**Re: Cooperative Hydro Embrun Inc. (Cooperative Hydro Embrun)  
Application for 2023 Electricity Distribution Rates  
OEB Staff Interrogatories  
Ontario Energy Board File Number: EB-2022-0022**

**OEB Staff Interrogatories  
Cooperative Hydro Embrun Inc.  
2023 Cost of Service Application**

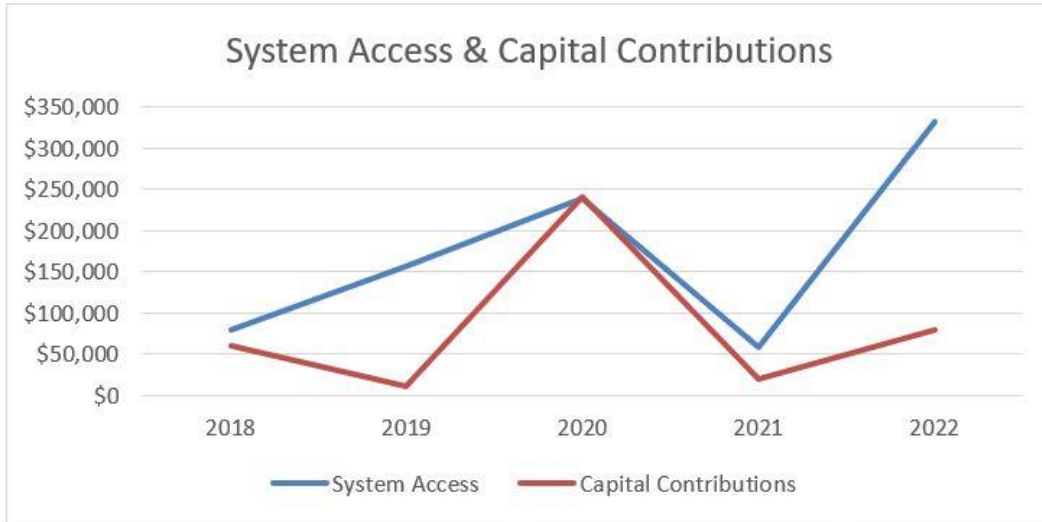
OEB staff prepared the following tables and figure based on the information provided in Table 2:
